D206-667-247TRN
Job Sheet 165936

Part Name: Crosstube Assembly, Mid Aft

TITLE SCALE
CROSSTUBE ASSY (206L MID AFT) NTS

DRAWING NO.	D206-667-247	TITLE	REV. A	DART AEROSPACE LTD ENGINEERING ORDER	D.E.O. NO.	D206-667-247-A-1	SHEET NO.	SHEET 1 OF 1	SCALE	NTS	
DRAWN	q	CHECKED	ASS	MFG. APPR. <i>[Signature]</i>	APPROVED	JMD	DE APPR. <i>[Signature]</i>	DATE	11.07.15	DATE	11.07.21

DRAWING NO. REV. A
D206-667-247 SHEET 1 OF 4

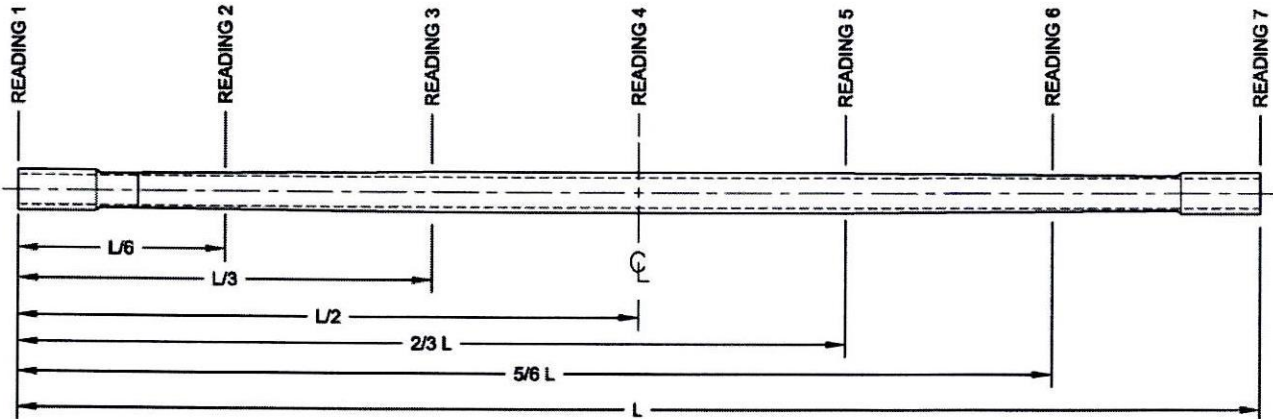
PURPOSE:
REPLACE MAGNOBOND WITH PROSEAL

NOTE 12 & 15, SHEET 1 IS AMENDED AS FOLLOWS:

(12) INSTALL D2892-1 SUPPORT USING 0.03" TO 0.06" THICK LAYER OF MAGNOBOND 6398 PER QSI 015. LET CURE FOR 12 HOURS AFTER INSTALLATION AND PRIOR TO PACKAGING.

(15) TORQUE CLAMPS 80 TO 100 IN.-LB. ENSURE AT LEAST 1.5 THREADS SHOWING IN SAFETY AND THAT NUT HAS NOT BOTTOMED-OUT AFTER TORQUING.

(12) TO INSTALL D2892-1 SUPPORT. ABRASE MATING SURFACE OF SUPPORT AND CROSS-TUBE WITH 180-GRIT SANDPAPER AND REMOVE RESIDUE WITH MEK (OR EQUIVALENT). APPLY A 0.04" TO 0.07" THICK LAYER OF PROSEAL 890 CLASS B-2 (OR AMS-S-8802 CLASS B-2) SEALANT TO MATING SURFACE OF SUPPORT.

(15) TORQUE CLAMPS 80 TO 100 IN.-LB. ENSURE AT LEAST 1.5 THREADS SHOWING IN SAFETY AND THAT NUT HAS NOT BOTTOMED-OUT AFTER TORQUING. PRIOR TO PACKAGING, RE-CHECK TORQUE ON CLAMPS AFTER PROSEAL 890 SEALANT HAS CURED FOR 72 HOURS.
